# Access Compliance Report

## Public Rights-of-Way

### (Curb Ramps)

Intersection ID: 46930	Main Street: SUTTER_CREEK_LN	Cross Street: LIVERMORE_LN	Location: NW
ADA ID: 9F1773505A9D	Ramp Type: PerpDiag	Initial Pass/Fail: Fail	Overall Compliance: No
Severity Score: 13.75			
Codes/Mitigation Info/Possible Solution		Field Measurements/Component Compliance

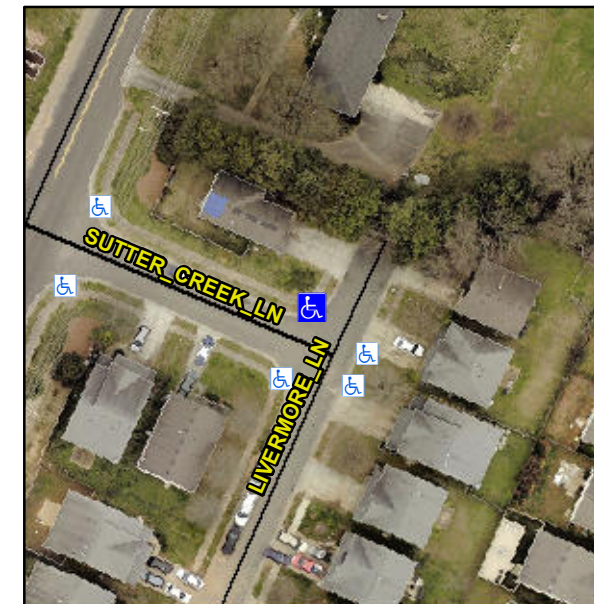
**Not Found, R304.2.2, R304.5.3**

Compliance	Description	Data	Compliance	Description	Data
N/A	Ramp Length (in)	44.0	No	Ramp Slope (%)	10.2
Yes	Ramp Width (in)	48.0	No	Ramp XSlope (%)	3.5
N/A	Flare Type LT	N/A	N/A	Flare Type RT	N/A
N/A	Flare Slope LT (%)	N/A	N/A	Flare Slope RT (%)	N/A
N/A	Flare Traversable LT?	N/A	N/A	Flare Traversable RT?	N/A
N/A	Landing Length (in)	N/A	N/A	DWS Provided?	N/A
N/A	Landing Width (in)	N/A	N/A	DWS Contrast?	N/A
N/A	Landing Slope (%)	N/A	N/A	DWS Length (in)	N/A
N/A	Landing X Slope (%)	N/A	N/A	DWS Full Width?	N/A
N/A	Landing Curb? (Y/N)	N/A	N/A	DWS Offset (in)	N/A
N/A	Shared Landing?	N/A			
N/A	Gutter Ponding?	N/A	N/A	Gutter Slope (%)	N/A
N/A	Gutter Lip Ht (in)	N/A	N/A	Gutter X Slope (%)	N/A
N/A	Painted X Walk1?	No	N/A	Painted X Walk2?	No
	X Walk 1 Direction	To SW		X Walk 2 Direction	To SE
N/A	X Walk 1 Width (in)	N/A	N/A	X Walk 2 Width (in)	N/A
	X Walk 1 Slope (%)	3.7		X Walk 2 Slope (%)	4.3
	X Walk 1 X Slope (%)	0.2		X Walk 2 X Slope (%)	4.0

**Remove & Replace Curb Ramp With Two New Directional Ramps or Equivalent.**
